# Planning Commission Agenda Report

June 27, 2018  
Item 6.b.

- SUBJECT:** P18-0113
- APPLICANT:** Don Cape, Tharaldson Hospitality Development
- PROPERTY OWNER:** Johnson Drive Holdings I LLC
- PURPOSE:** Application for Design Review (DR) approval to construct two new hotels totaling 231 rooms, a drive-through coffee shop and related site improvements within the Johnson Drive Economic Development Zone (JDEDZ)
- LOCATION:** 7280 Johnson Drive
- GENERAL PLAN:** Retail/Highway/ Service Commercial; Business and Professional Offices
- ZONING:** Planned Unit Development – Commercial (PUD-C) District
- EXHIBITS:**
- A. [Draft Resolution and Conditions of Approval](#)
  - B. [Revised Project Plans dated "Received June 19, 2018"](#)
  - C. [Zoning Administrator approved Project Plans dates "Received May 4, 2018"](#)
  - D. [JDEDZ Development Standards and Design Guidelines March 2017](#)
  - E. [Location and Notification Map](#)

**Figure 3: View simulations**

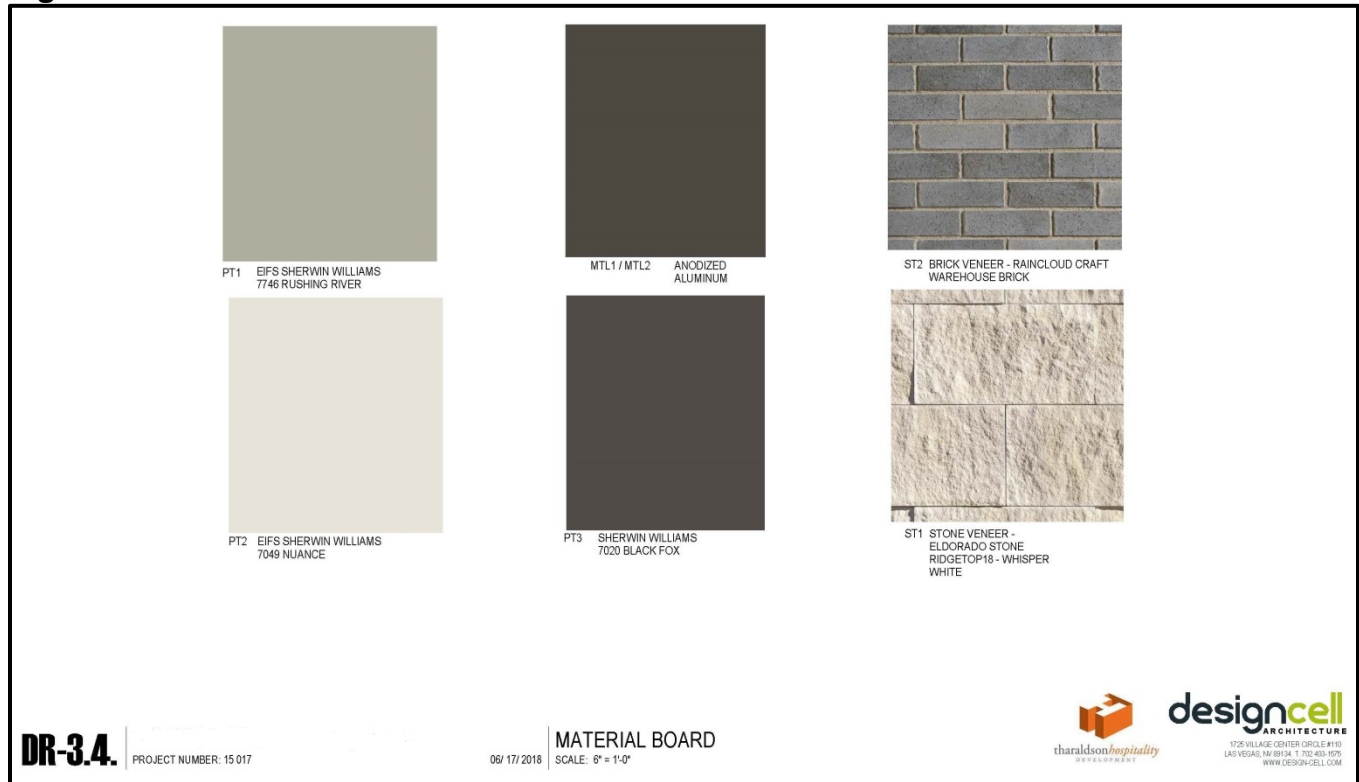
**BUILDING DESIGN:** With the plans submitted for a building permit, the applicant shall revise the south elevation for the Springhill Suites (Plan Sheet DR-4.1) to have a similar aesthetic/design quality to the west elevation for the Towneplace Suites (Plan Sheet DR-4.3). The revisions shall be reviewed and approved by the Director of Community Development.

**BUILDING MATERIALS AND COLORS:** With the plans submitted for a building permit, the applicant shall revise the paint scheme subject to review and approval by the Director of Community Development. The final building materials and colors/paint scheme shall be stated on the building permit plans.

**ACCENT LIGHTING:** With the plans submitted for a building permit, the applicant shall revise the building elevations for both the Springhill Suites and Towneplace Suites to include accent lighting subject to review and approval by the Director of Community Development.

*Additional windows were added to the south elevation of the Springhill Suites (see Exhibit B, Plan Sheet DR-4.1) to add visual interest and provide a more “open” façade for the side of the building facing Johnson Drive.*

*After consideration of comments about facade materials, a new color scheme was developed. Please see the modified elevations in Exhibit B. The color “Copper Mountain” was removed from the Towne Place Suites scheme. Similarly, the Springhill Suites colors were adjusted (“Garden Spot” accent color removed) to ensure that both buildings complement each other.*

*Additionally, the proposed El Dorado stone material, which staff felt to be overly plain and too similar to the texture of the building stucco, were replaced. The Zen24 Nickel gray-colored stone was replaced with “Raincloud Craft Warehouse Brick” veneer. The new proposed brick veneer offers a more textured surface and of finer quality, and fits well with the building color scheme. The Zen24 Soft Light light-colored stone was replaced with “Ridgetop18-Whisper White” stone veneer. This material has a richer texture and its color and texture scale fits well with the building color scheme.*

*Wall sconces and building up-lights were added to both buildings to accentuate prominent building elevation spots and entrances. Downlights are also used in porte-cochere ceilings to brighten main entrance areas.*
